Access Compliance Report Public Rights-of-Way (Curb Ramps)

ADA ID: RPRK220207144054 Ramp Type: Type 6 - Directional 1 Initial Pass/Fail: Fail Overall Compliance: No Severity Score: 15

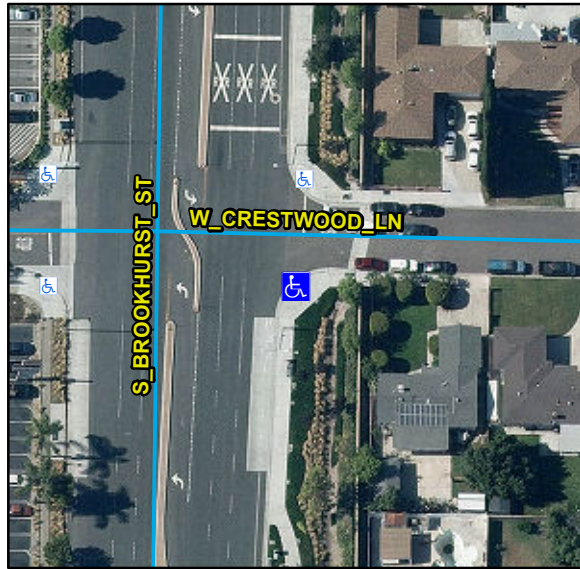
R304.5.3, STD 1115

Remove & Replace Entire Ramp.
